STREETS, BUILDINGS & UTILITIES COMMITTEE

January 5, 2021

Subject: Old road discontinuance - CSM two Lot division & road dedication Markesan, Green Lake Co.

A

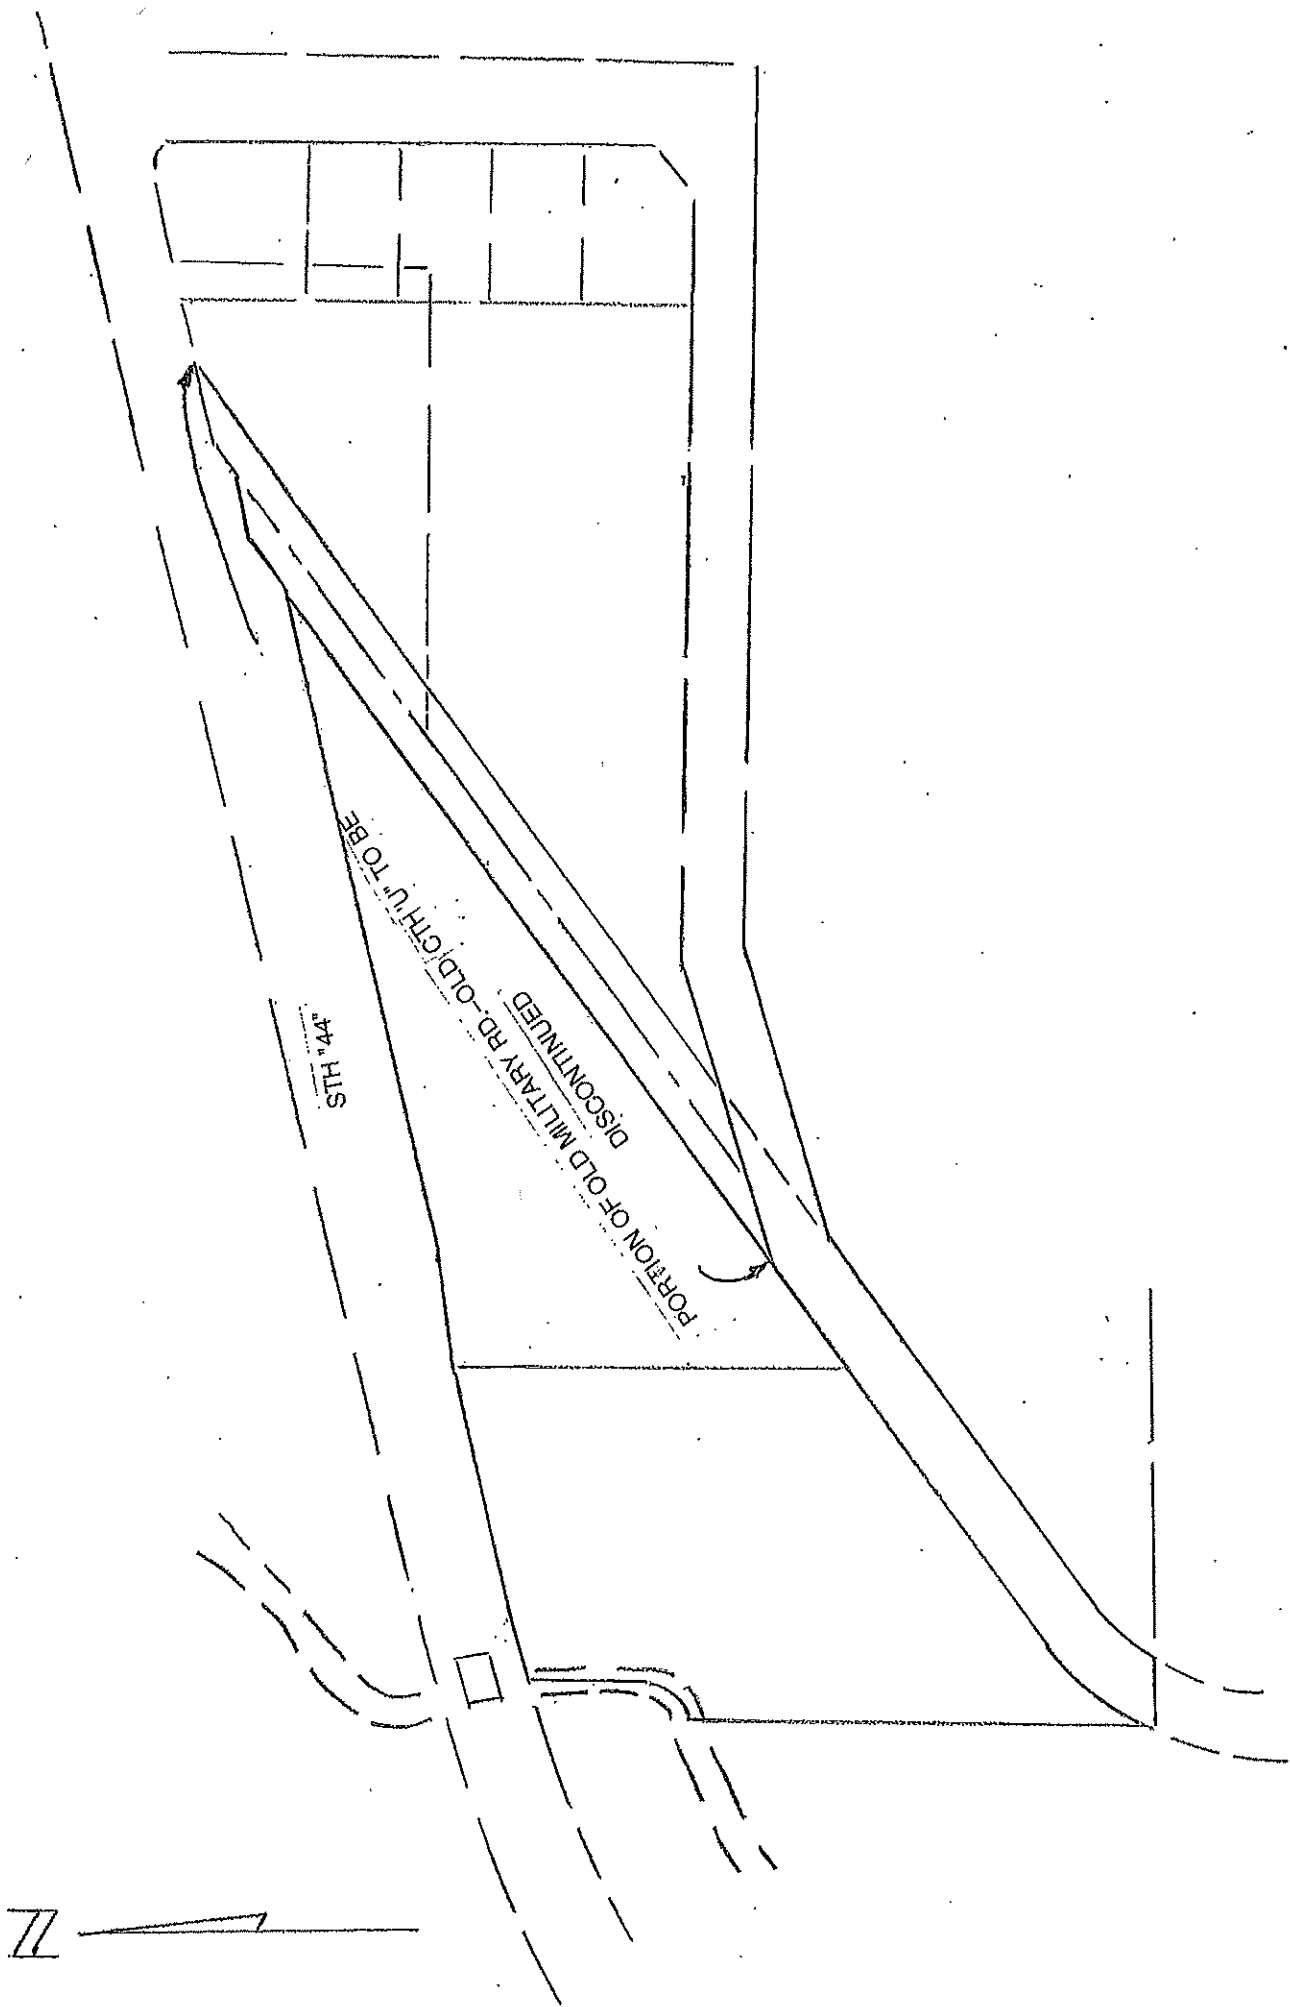
Hi Rich - See attached sketches "A" & "B". I think you need at least a Plat of Survey showing the portion of road to be discontinued - "A". After the City takes action to discontinue, they need to quit claim the portions to the three adjoining property owners - any future title search will reveal that any Interest the City had, reverted back to the three adjoiners - no questions. Then a CSM of the two Lots and the road dedication completes the land division & gives the City title to Airport Drive as it extends to present CTH"U".

Note; the other sketch, showing various outlots as part of the old R/W, shows how you and the neighbors could split the old R/W , before the CSM is finalized. Since the new lots would have access to the highway & to the local road, driveway permits onto "44", if wanted, need to be addressed. Discuss? In tomorrow for a short time, then off 'til next week.
